Service Bulletin

NO:PV1-02-002

SUBJECT: Attention When Replacing The Cassette Compartment

MODEL(S): MDX-M2000

Spring attaching direction

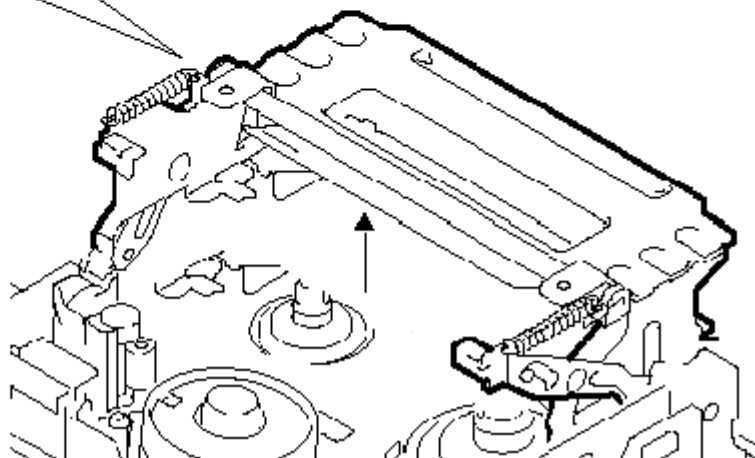
Attention when replacing the cassette compartment. The repair part [coil spring] is missing from cassette compartment assy (X-3951-298-2), use the spring from the defective cassette compartment assy.

R type hook should be put on ,like this picture, always in this direction of the arrow.
